SN J3953B-01

S E R V I C E N O T E

J3953B VQT

Updated replacement of analog card for improved PESQ scores

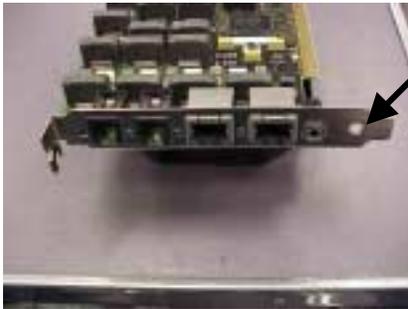
Replace the analog FXO E&M card with the latest version. This, along with downloading the VQT application Software Version 4.1.1 or later will correct the noise interference improve the PESQ scores. When the “defective” analog card is removed the metal grounding tab **MUST** be swapped to the new assembly. In the J3953B you will also need to add the VQT grounding assembly 5065-8300, if it has not already been added.

Move metal ground tab
to new assembly.
